REPORT
ON
PROJECT
OF THE
United Comstock Pumping Association
FOR
Unwatering the North Comstock Mines
ANSWERING FORTY-SEVEN QUESTIONS
OF
MR. WHITMAN SYMMES

A. M. WALSH,
Supt. U. C. Pumping Association
— TO —
WHITMAN SYMMES,
Supt. Mexican Mine

VIRGINIA CITY, NEV.
October 29, 1913

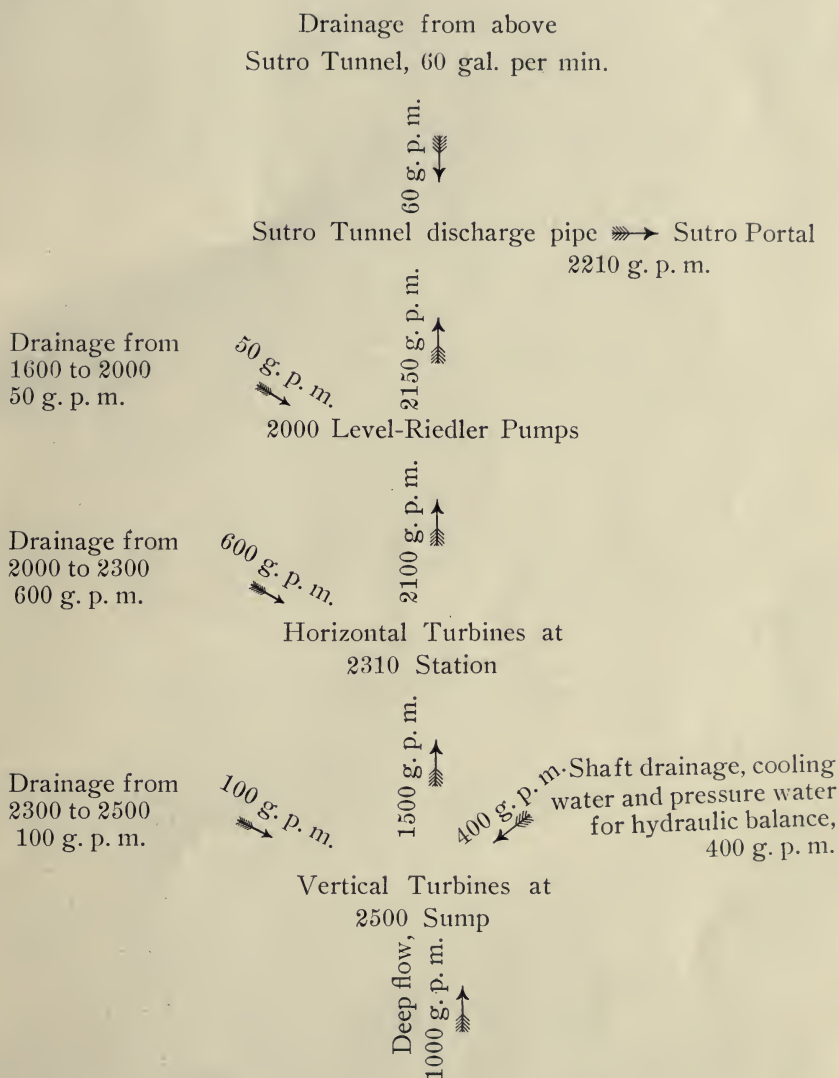
The pumping system may be outlined as follows:

A simple expression of these relations may be made by diagram as follows:

The installation described is by no means a logical one or even a good one, and presumably the whole of it will be replaced in

DIAGRAM 1

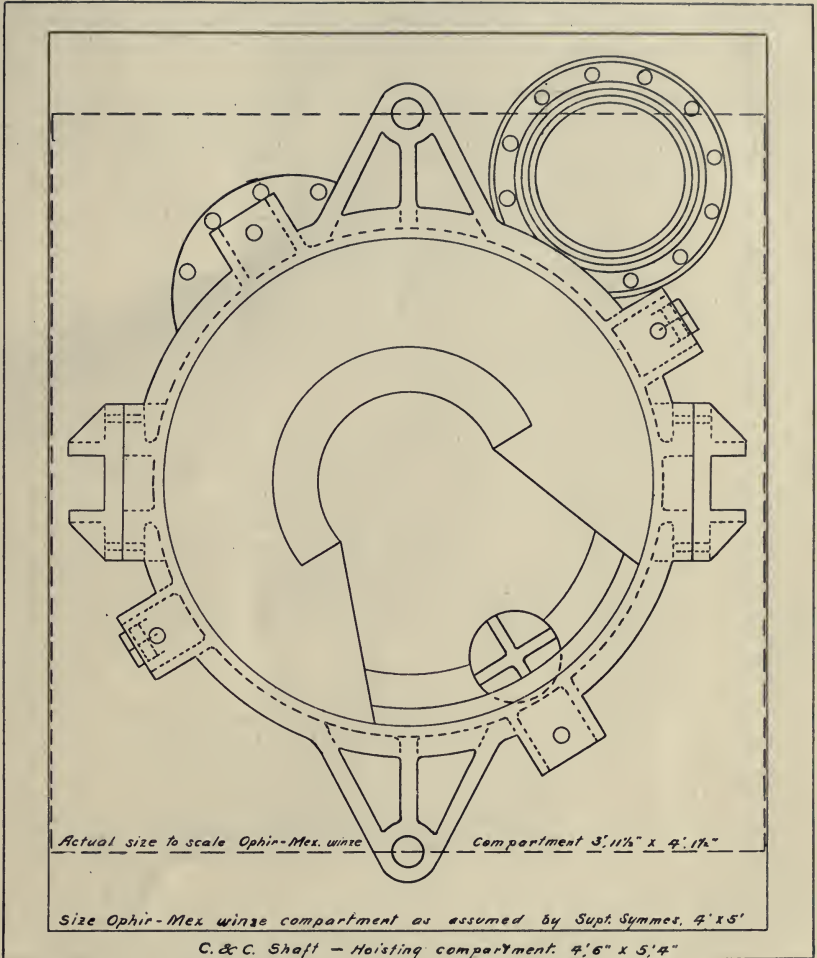
On assuming the management I found, among the papers of the Pumping Association, a drawing of the Ophir-Mexican winze compartment, which shows it to be four feet wide and five feet long. Compartments of this size might, theoretically, permit the passage of the electrical sinker, though actually there would be serious difficulties involved in the operation.

However, a careful examination of the winze disclosed the fact that its compartments are really but 3 feet 11½ inches wide by 4 feet 1½ inches long, a circumstance accounted for by Mr. McCormick as follows: In former times each mine made its own ore cars from designs more or less dependent upon the caprices of the various superintendents. In this way it chanced that Con-Virginia used rather large cars, which resulted in winze compartments in that mine of a size, 4 feet 4 inches by 4 feet 7 inches, while Ophir on the other hand, had only small cars, for the passage of which smaller winze compartments were adequate. When you made your plans for using the electrical sinkers in the Ophir-Mexican winze, it appears that you must have deceived yourself by a failure to sound and plumb the winze beneath the water level at its collar. If you should now care to do this you will find that the compartments really measure 3 feet 11½ inches by 4 feet 1½ inches as I have stated, except in the first four feet below the winze collar, where the timbers are widened out to allow room for the installation of chairs for the cage.

Had the Ophir-Mexican Winze compartments been four feet by five feet as shown by diagram left by you in the office records, it would even then have been almost a hopeless task to pass the pumps through them. But as the compartments actually are, this would be entirely out of the question. If the pumps were hung above them as they were intended to be hung they would protrude about 6 inches into the timbers.

DIAGRAM II

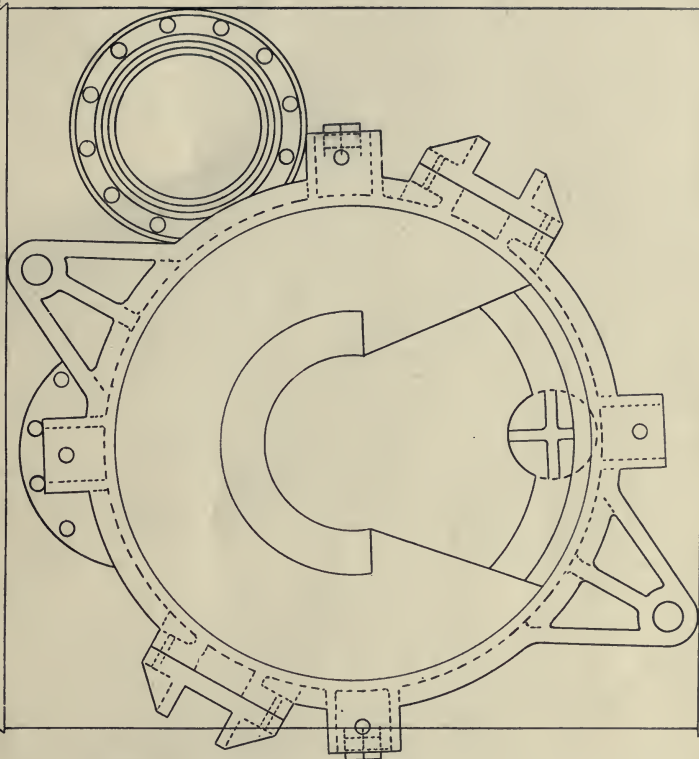
As a matter of purely academic interest I have placed a cross-sectional drawing of the pump on tracing cloth and turned it about over a diagram of the winze compartment to ascertain the most favorable position in which the pump could be presented to the winze. The result is shown in diagram No. 2, and even so, the pump would protrude a minimum of $2\frac{1}{2}$ inches into the timbers, assuming a theoretical clearance of nothing for the other parts of the pump. However, we cannot venture to assume the winze is perfectly straight by any means and a pump 16 feet long would require some additional clearance to allow for this factor. Moreover, in an old cribbed winze, we can be sure some of the timbers will protrude as much as two inches; and in some places we may expect such bulges to be found on both sides. Therefore, it may be taken as an entirely safe assumption that the winze would need to have a clearance of at least six inches over an exact fit when the pump is in the most favorable position for passing through the compartment which means that at least one dimension of the winze must be as much as $8\frac{1}{2}$ inches greater than it is. But even this would only give a fighting chance to lower the pump, as a $6\frac{1}{2}$ tons pump lowered in free suspension on a cable without guides is not a sufficiently reasonable thing for consideration in conservative engineering practice.

Summarizing this fourth decisive factor it is seen that the Ophir-Mexican winze could not possibly be used for the turbine
